INITIAL STUDY

Environmental Checklist and Evaluation for the County of Santa Clara

File Number:	PLN18-11451	Date: 1/12/2021
Project Type:	Building Site Approval and Grading Approval	APN(s): 142-15-008
Project Location / Address:	3343 Alpine Road	GP Designation: Hillsides
Owner's Name:	Toni Cupal	Zoning: Hillsides
Applicant's Name:	McKenzie Brooks	Urban Service Area: NONE
Project Description		
<p>The project is a Building Site Approval and Grading Approval application to construct a 6,882 square foot, two-story single-family residence located at 3343 Alpine Road (APN: 142-15-008) see Attachment 2 – Plan Set. The subject property is 4.2 acres in size and is characterized as a long strip of land running north to south along Los Trancos Creek, which borders the western side of the parcel. To the east of the parcel is property owned by Stanford University, used as a nursery. To the north, west, and south of the parcel is Ladera Oaks Swim & Tennis Club, a baseball field, and vacant area with a trail, which are all within the Town of Portola Valley.</p> <p>An existing driveway, constructed within a 30-foot wide right-of-way easement, connects the property to the nearest publicly maintai

OVERALL SITE PLAN

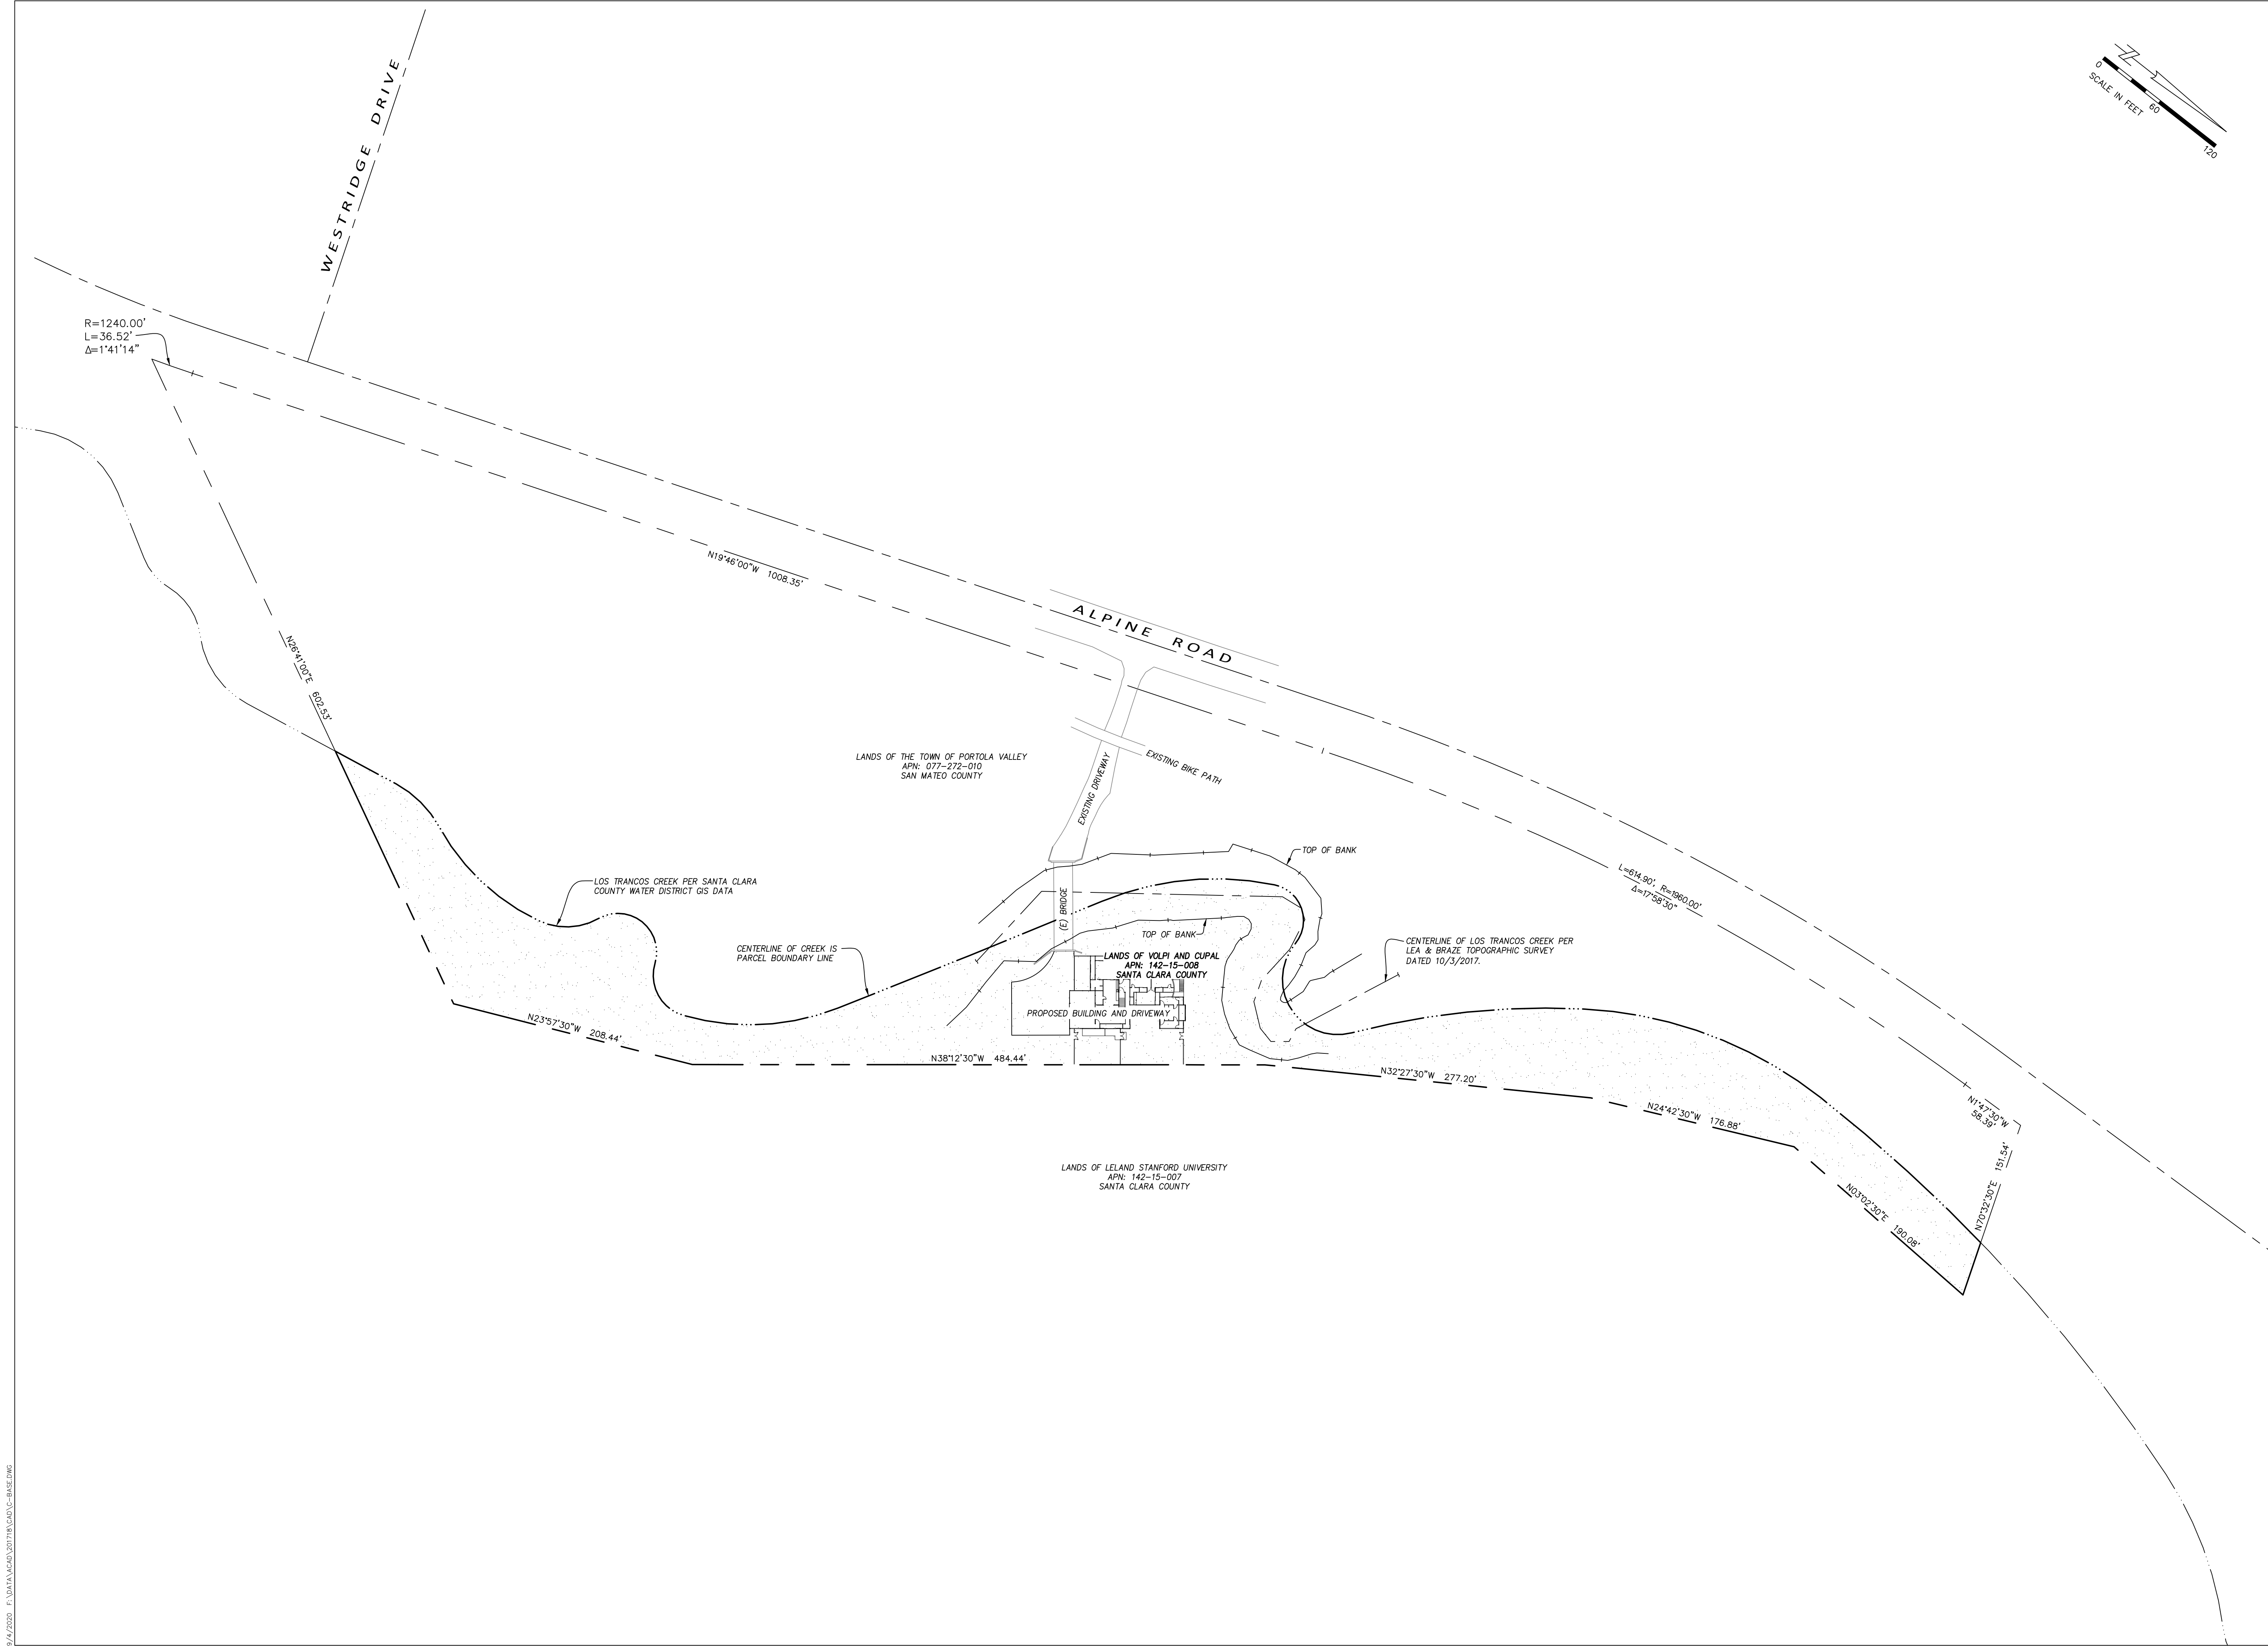
1. Please revise the overall site plan (Sheet C2.2) to correctly show the location of the property boundaries. It has come to Staff's attention while conducting the environmental assessment that property line designations were not accurately/consistently illustrated on the project plans. This information is required to avoid complications with the final published/posted environmental document.

Response: Sheet C2.2 has been revised to more clearly indicate the subject parcel, using hatching, differing line weights, and additional notations.
